## **Robins and Day, 632 Chiswick High Road (00248/B/P22)**

### **Comments from the West Chiswick and Gunnersbury Society**

630 Chiswick High Road

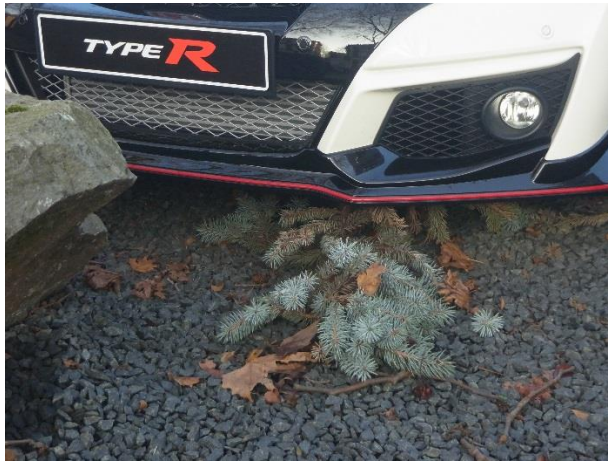
**Landscaping** The Society is pleased to note that trees planted on the frontage will be provided with suitable protection. This is important in view of the threat posed by display vehicles (see photos of Honda forecourt in Annex).

Condition 7 of Planning consent 00890/O/AD13 (October 2012) required planting of a semi-mature tree on Chiswick High Road forecourt

Crushed tree – Honda forecourt Jan 2017

Dead tree – Honda forecourt March 2017
